**SUBARU.****QUALITY DRIVEN® SERVICE****SERVICE BULLETIN**

APPLICABILITY: 2020-23MY Legacy & Outback
2020-23MY Crosstrek
2022-23MY Forester Wilderness

NUMBER: 16-149-25

SUBJECT: TR580 Control Valve & Connector Cover /
DTCs P2721, P2763, P0974, & P0977

DETAILS OF DESIGN CHANGE:

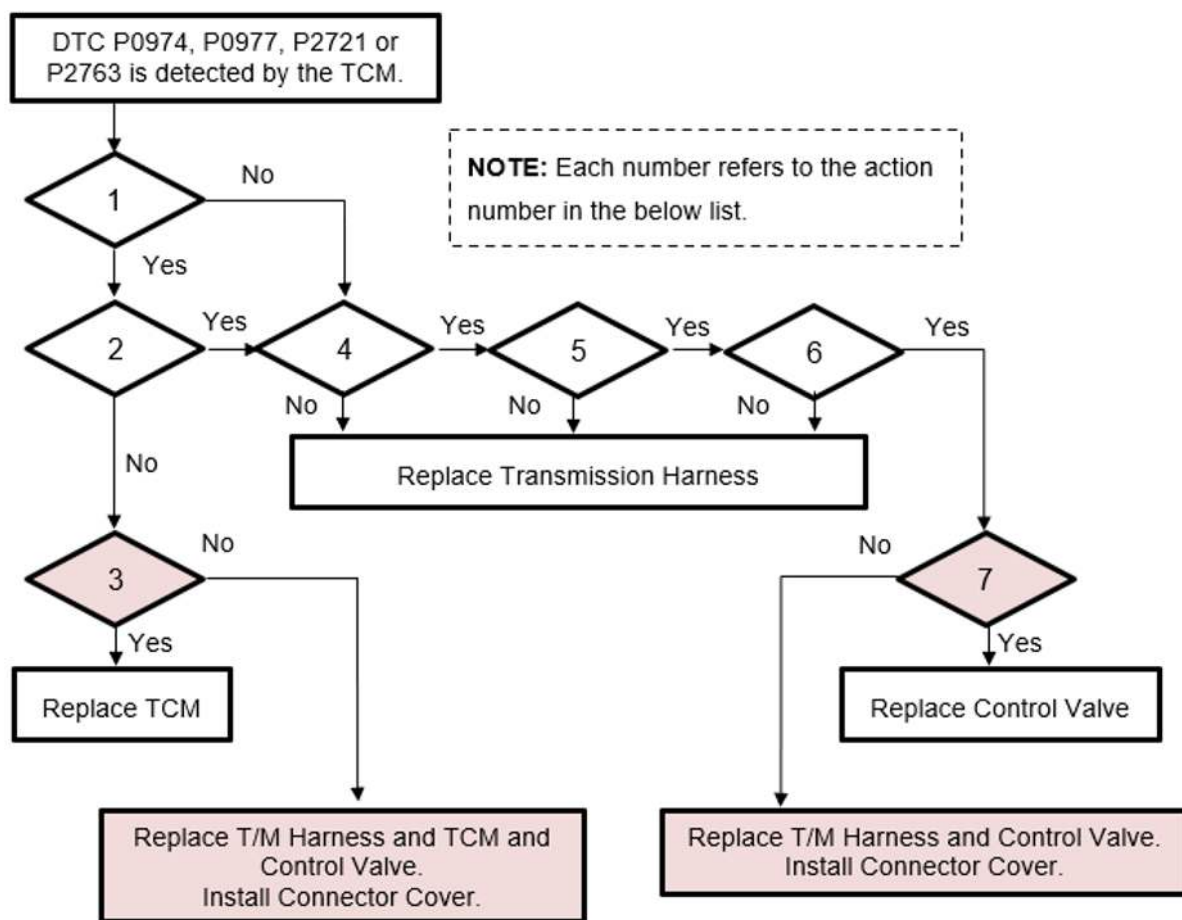
The new control valve and cover have been incorporated into vehicle production as per the table below.

REMOVING AND INSTALLING THE CONNECTOR COVER:

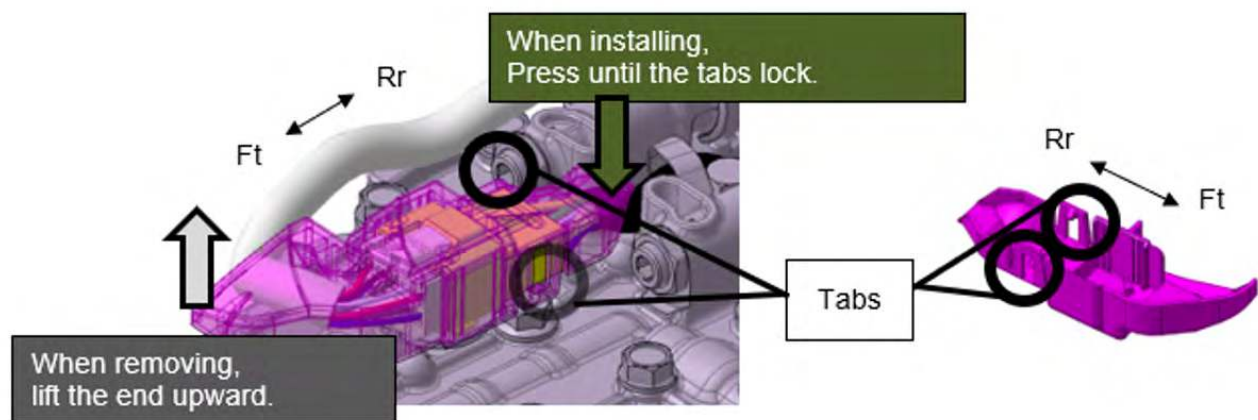
No.	Inspection List	Yes	No	Procedure Change from Current S.M.
6	Inspect the transmission harness (short to power supply). Measure the voltage between TCM connector and transmission body. (*)	Go to 7	Replace T/M Harness	The flow changes in the case of 'Yes'.
7	Confirm if the connector cover has been attached or not.	Replace Control Valve	Replace T/M Harness and Control Valve. Install Connector Cover.	Additional flow
